HISTORIC AND DESIGN REVIEW COMMISSION

HDRC CASE NO:	2025-100
ADDRESS:	312 PEREIDA ST
LEGAL DESCRIPTION:	NCB 933 BLK 5 LOT 3
ZONING:	RM-4
CITY COUNCIL DIST.:	1
DISTRICT:	King William Historic District
APPLICANT:	Jim Tafoya/BRIO BUILDERS
OWNER:	David Vexler/VEXLER DAVID R
TYPE OF WORK:	2-story addition construction
APPLICATION RECEIVED:	April 01, 2025
60-DAY REVIEW:	May 31, 2025
CASE MANAGER:	Bryan Morales

The applicant is requesting a Certificate of Appropriateness for approval to construct a 2-story rear addition.

PROPOSED FRONT ELEVATION

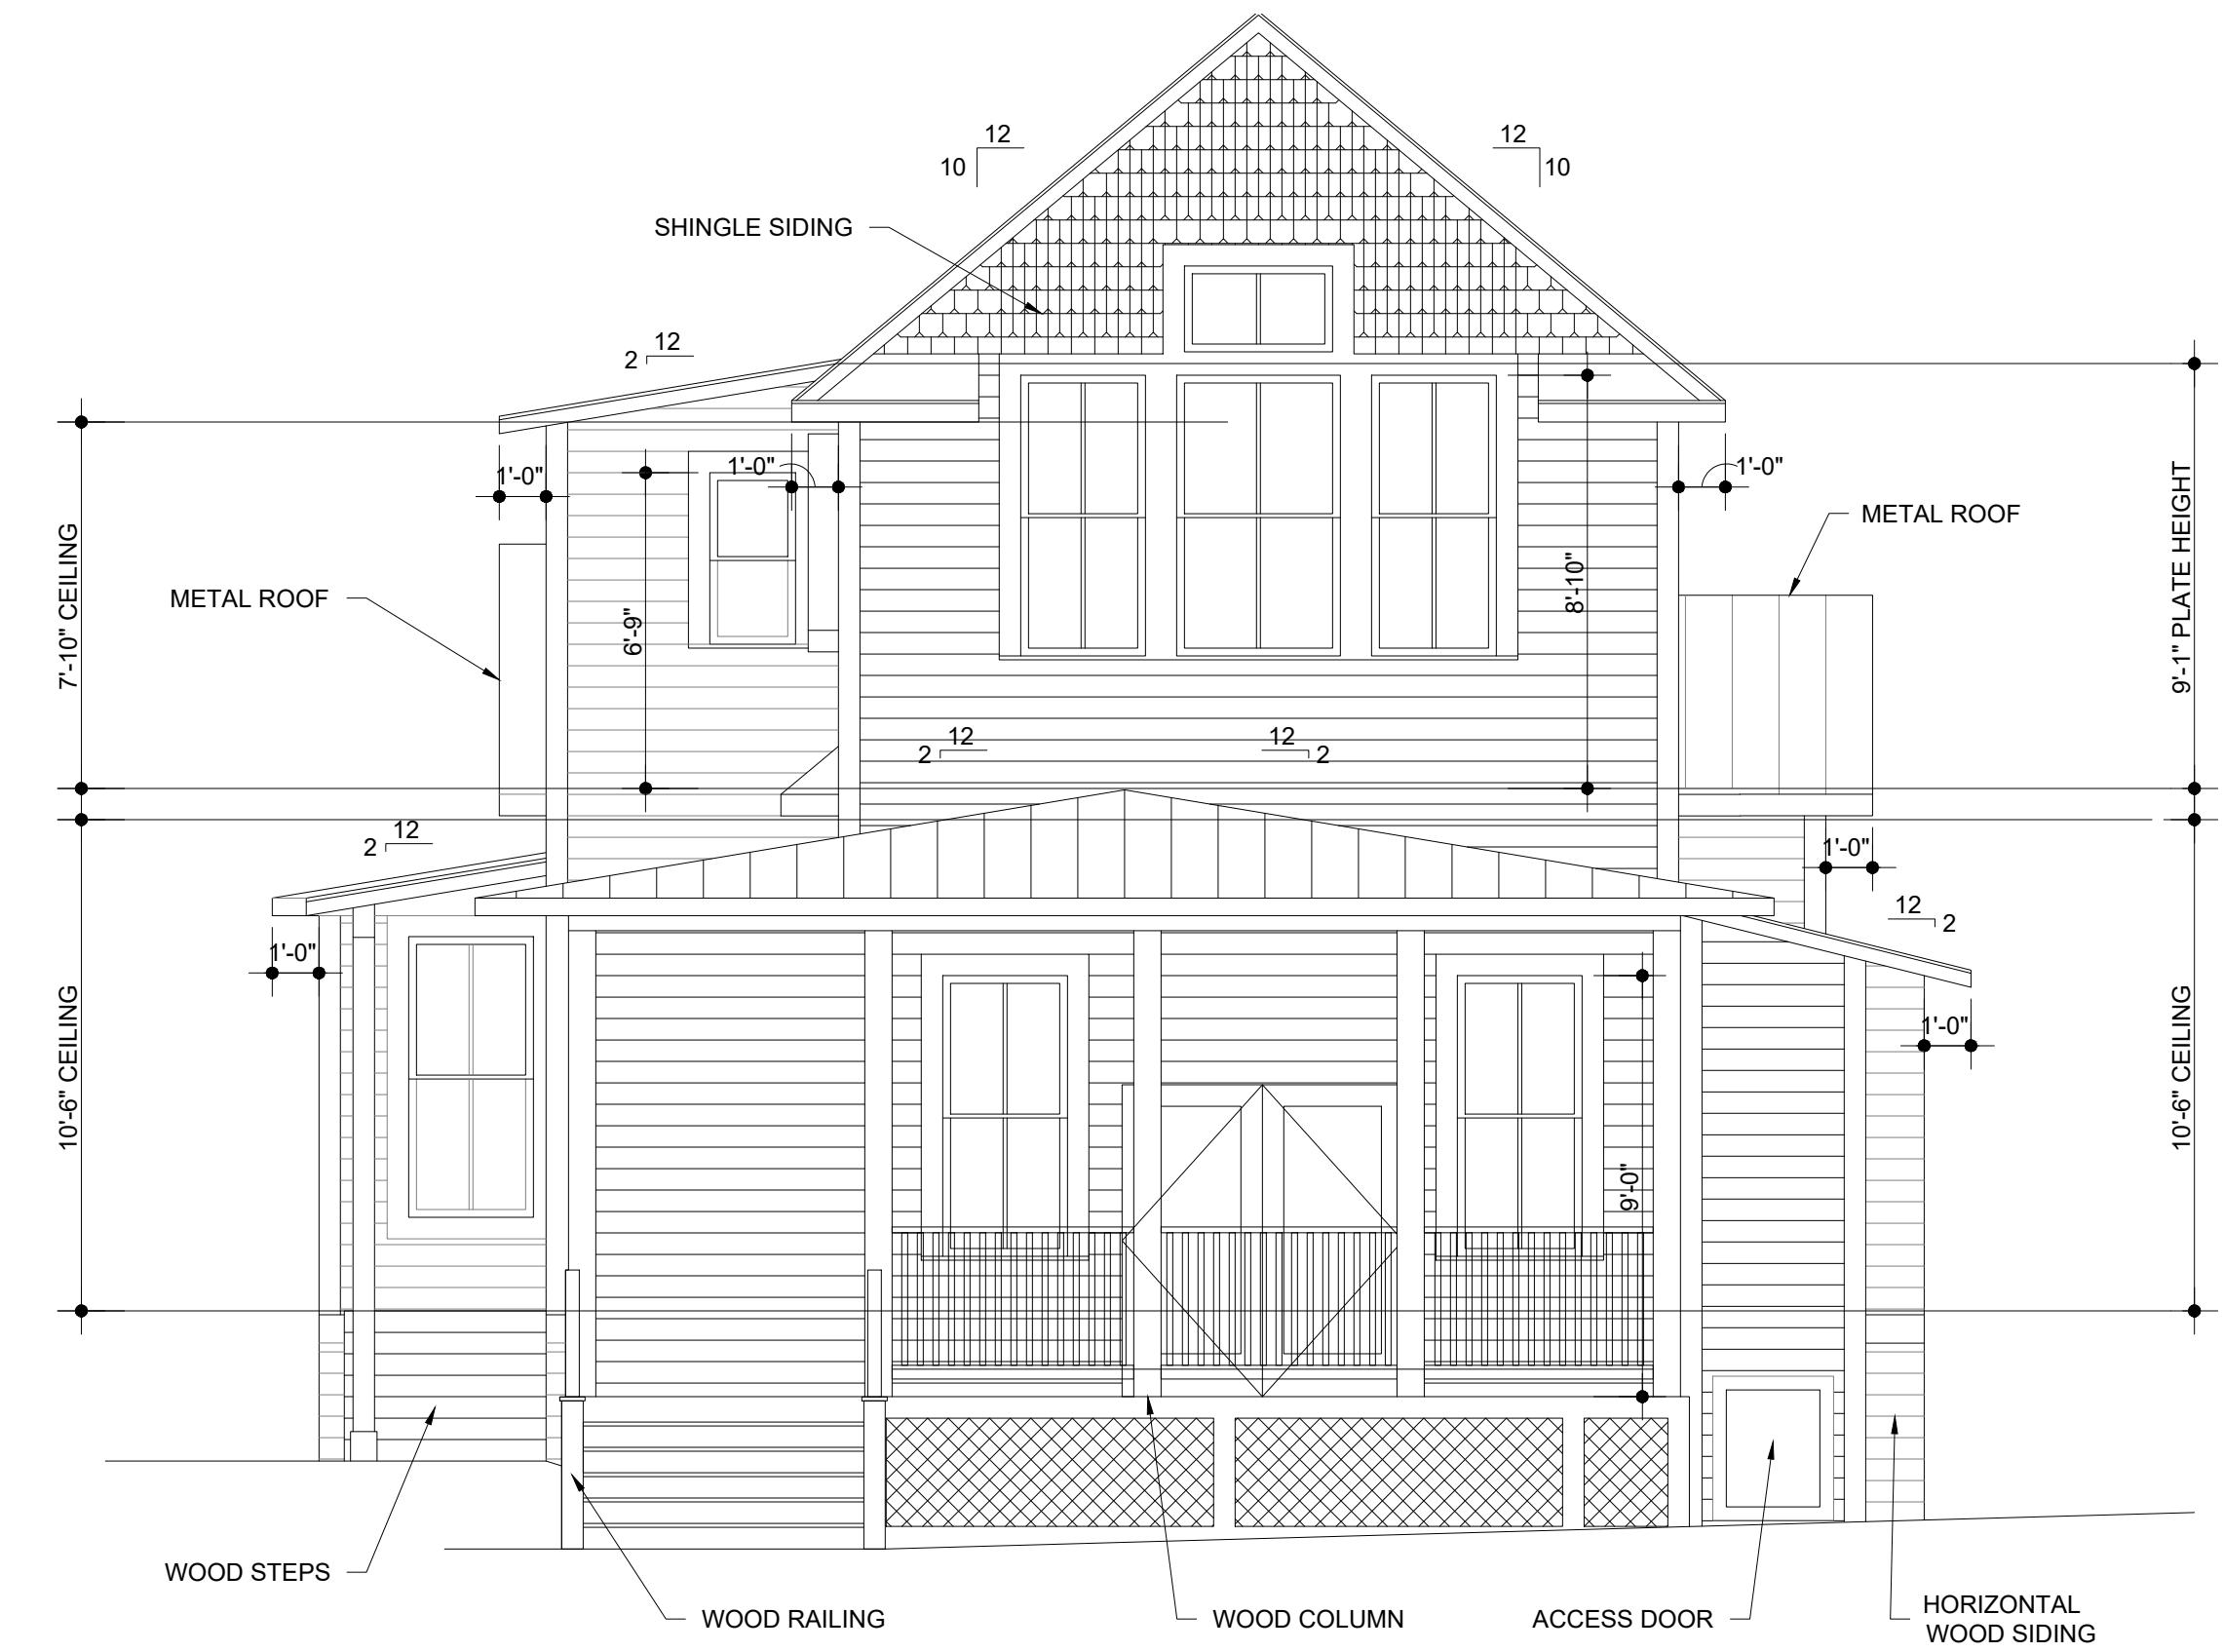
- i. REAR ADDITION (NEW WINDOWS: SIZE AND PROPORTION) – The applicant is requesting approval to install one sliding window and two clerestory windows on the front façade; two two-over-two windows on the right façade; and two two-over-two windows on the left façade. The Standard Specifications for Windows in Additions and New Construction clarifies that new windows on additions should relate to the windows of the primary historic structure in terms of materiality and overall appearance. In addition, whole window systems should match the size of historic windows on the property unless otherwise approved and windows should feature traditional dimensions and proportions as found within the district. Staff finds the installation of the proposed two-over-two windows conforms to Guidelines. Staff finds the proposed clerestory and sliding windows do not conform to Guidelines. Staff recommends the applicant incorporate a single-sashed window or replicate the existing rectangular historic wood window instead of the proposed clerestory and sliding windows.

- j. REAR ADDITION (RELATIONSHIP OF SOLIDS AND VOIDS) – According to the Historic Design Guidelines, new construction should incorporate window and door openings with a similar proportion of wall to window space as typical with nearby historic facades. Windows, doors, porches, entryways, dormers, bays, and pediments shall be considered similar if they are no larger than 25% in size and vary no more than 10% in height to width ratio from adjacent historic facades. Avoid blank walls, particularly on elevations visible from the street. No new façade should exceed 40 linear feet without being penetrated by windows, entryways, or other defined bays. Staff finds the proposed fenestration pattern on the rear 2-story addition generally appropriate; however, staff recommends the applicant incorporate a single-sashed window or replicate the existing rectangular historic wood window instead of the proposed clerestory and sliding windows.

MS: I think the added bedroom seems really large. By pulling it away from the house (behind the gable) that would help a lot. RA: Would an option would be to move the gable itself toward the street. MS: Not really. Push that addition as far back as possible. The new addition's front facing windows should feature more traditional proportion windows (i.e. vertical). The windows just look odd. I would recommend replicating windows found elsewhere.

JC: I agree with MS. The front facing windows are a concern. RA: I'll work on this and will reduce the total sqft.

- i. That the applicant submit to staff accurate drawings including correctly scaled architectural features such as existing side gables.
- ii. That the applicant use lapped siding for the addition to match the existing 2-story rear addition's siding in material, profile, installation, and finish.
- iii. That the applicant incorporate a vertical trim piece between the proposed addition and existing addition.
- iv. That the applicant install fully wood or aluminum-clad wood windows that meet staff's standard window stipulations and submits updated specifications to staff for review and approval. The windows should feature an inset of two (2) inches within facades and should feature profiles that are found historically within the

immediate vicinity. Meeting rails must be no taller than 1.25" and stiles no wider than 2.25". White manufacturer's color is not allowed, and color selection must be presented to staff. There should be a minimum of two inches in depth between the front face of the window trim and the front face of the top window sash. This must be accomplished by recessing the window sufficiently within the opening or with the installation of additional window trim to add thickness. Window trim must feature traditional dimensions and architecturally appropriate sill detail. Window track components must be painted to match the window trim or concealed by a wood window screen set within the opening. The proposed clerestory and sliding windows for the addition must replicate an existing window found onsite.

PROPOSED LEFT ELEVATION

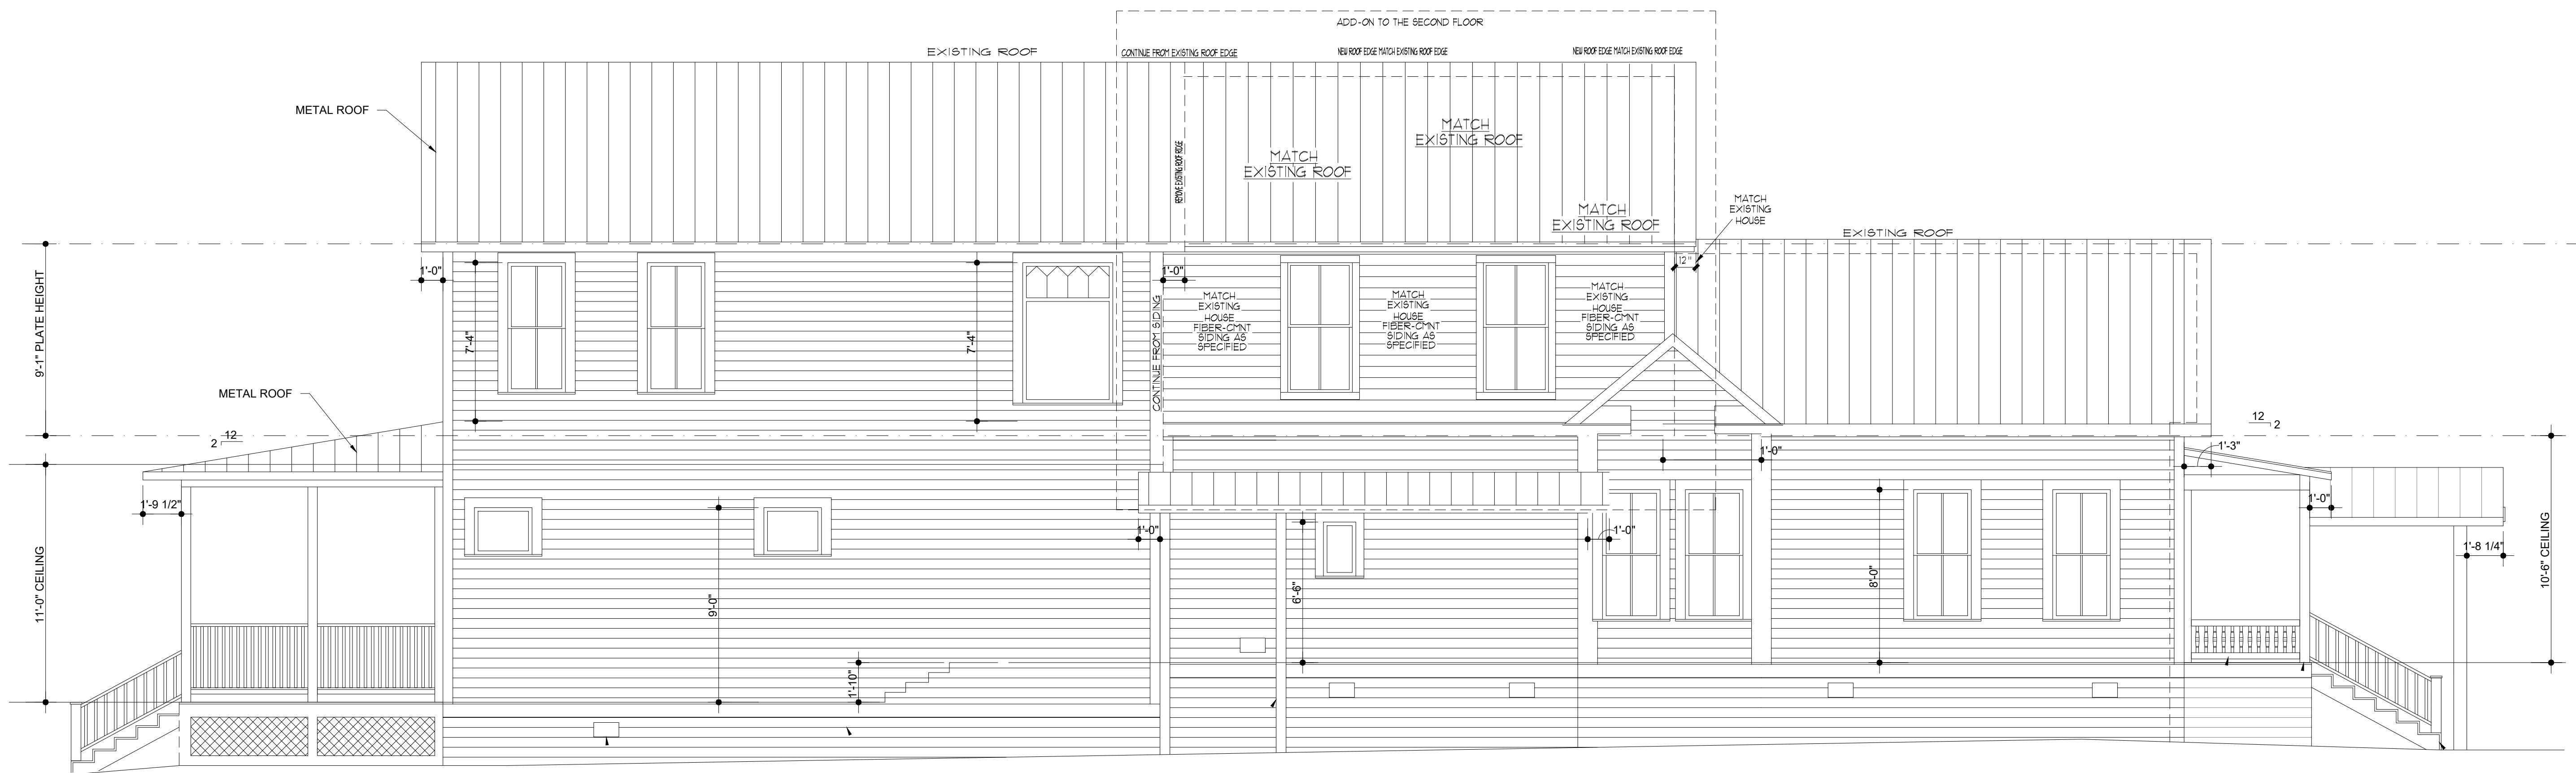
- c. REAR ADDITION (MASSING & FOOTPRINT) – The applicant has proposed to construct a 2-story rear addition. The second story will add approximately 574 sqft. The existing primary structure is a 2-story, single-family structure. Additions 1.B.i stipulates residential additions should be designed to be subordinate to the principal façade of the original structure in terms of scale and mass. Additions 1.B.v states that generally, the height of new additions should be consistent with the height of the existing structure, the maximum height of new additions should be determined by examining the line-of-sight or visibility from the street, and the addition height should never be so contrasting as to overwhelm or distract from the existing structure. Additions 2.B.iv states the building footprint should respond to the size of the lot. An appropriate yard to building ratio should be maintained for consistency within historic districts. Residential additions should not be so large as to double the existing building footprint, regardless of lot size. The applicant has proposed to extend the existing front-facing gable 2-story addition toward Pereida St and situate the new addition behind the existing side-facing gable. Staff finds the proposed rear 2-story addition generally appropriate.

- g. REAR ADDITION (ARCHITECTURAL DETAILS) – The applicant is requesting approval to construct a 2-story rear addition. Additions 4.A.ii states additions should incorporate architectural details that are in keeping with the architectural style of the original structure. Details should be simple in design and compliment the character of the original structure. Architectural details that are more ornate or elaborate than those found on the original structure should not be used to avoid drawing undue attention to the addition. Additions 4.A.iii states applicants should consider integrating contemporary interpretations of traditional designs and details for additions. Use of contemporary window moldings and door surroundings, for example, can provide visual interest while helping to convey the fact that the addition is new. Additions 2.A.v recommends that for side or rear additions utilize setbacks, a small change in detailing, or a recessed area at the seam of the historic structure and new addition to provide a clear visual distinction between old and new building forms. Staff finds the proposed rear 2-story addition's architectural details generally appropriate; however, the applicant should install a vertical trim piece between the existing addition and proposed addition.

massing on the proposed addition. The house looks like it's being eaten by the addition. Use existing framing on the first floor to help with the addition. RA: I can work on this. MS: What kind of siding were you approved for? RA: I've included the cement fiber board. MS: The window configurations should be worked on as well.
